August 11, 2004

Refer to: HSA-10/WZ-190

Thank you for your letter of May 29, 2004, requesting Federal Highway Administration (FHWA) acceptance of your company's Anchor Sign Stand as a crashworthy traffic control device for use in work zones on National Highway System (NHS). Accompanying your letter were photographs and engineering drawings of the stand. You requested that we find these devices acceptable for use on the NHS under the provisions of National Cooperative Highway Research Program (NCHRP) Report 350 "Recommended Procedures for the Safety Performance Evaluation of Highway Features" based on comparison to your Type III barricade which was successfully crash tested using similar components.

Material Size note	Sheet: 1 of 1	Scale: Full	Title	Rev: 2/18/04	By: CMM	Manufacturer: DS8
Manufacturer name and address	Ergo-Soft Systems, Inc.		4000	ANCHOR SIGN Stone		
Author	Ergo-Soft Systems, Inc.		2/18/04

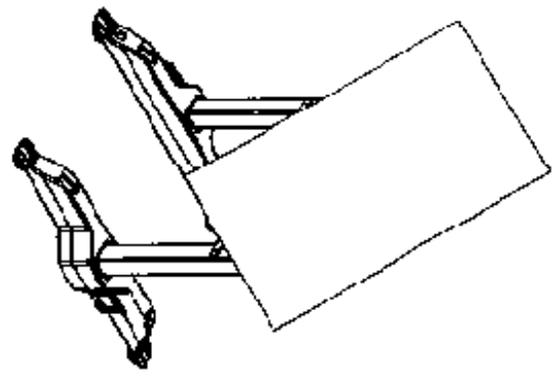
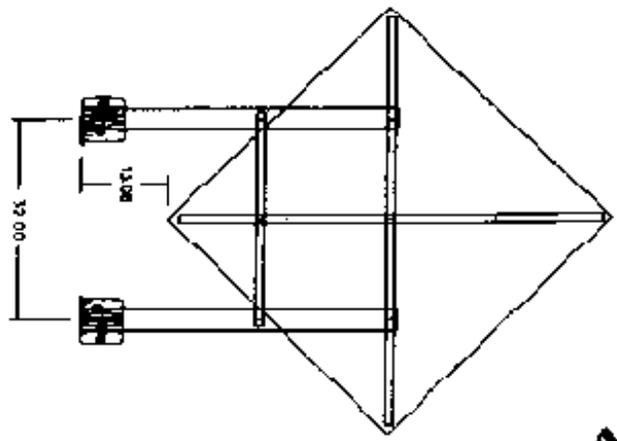
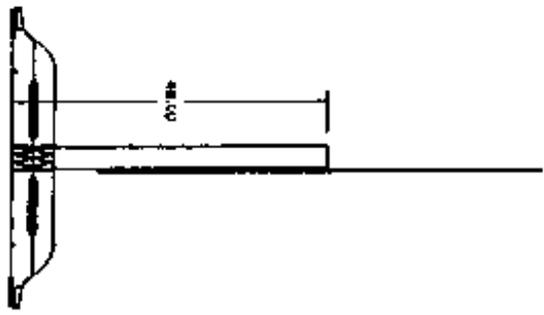
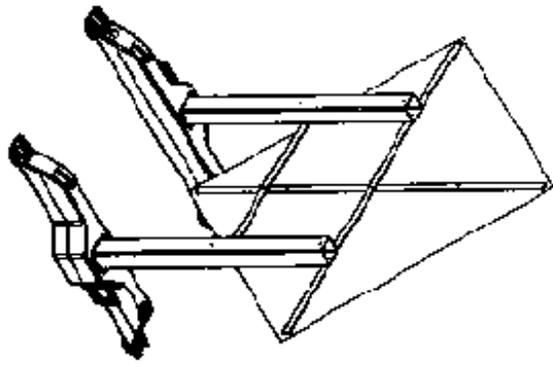
The Anchor Sign Stand consists of components which have been found acceptable in the PSS Type III barricade systems. The Anchor feet were accepted in the FHWA acceptance letters WZ-152 and WZ-166. The HDPE uprights are the same as those accepted in WZ-61, WZ-152, and WZ-166. The stand will support a 48x48 inch diamond roll-up sign at a mounting height of approximately 13 inches and a top height of approximately 80 inches. The pultruded fiberglass

spreaders supporting the roll up sign are 1 1/4 inch wide. The maximum thickness of the vertical spreader is 1/4 inch, and the maximum thickness of the horizontal spreader should be 3/16 inch. An additional 34-inch long fiberglass rib is attached to the uprights and the sign's vertical spreader at a height of 25 inches above the ground to provide additional stability.

The components of this stand conform to those used in your crash tested and accepted Type III barricade. Also the proposed sign stand can be considered a "compact" portable sign stand that has no substantial components that are likely to come in contact with the windshield. The typical "compact" stand is an "X-footprint" design with a steel or aluminum mast no taller than approximately 12 to 18 inches tall that supports the vertical fiberglass spreader of a roll up sign.

We concur in your assessment that the Anchor Sign Stand would meet the crashworthiness requirements of the FHWA and, therefore, the devices described above and detailed in the enclosed drawings are acceptable for use on the NHS under the range of conditions the "parent" type III barricade was tested, when proposed by a State.
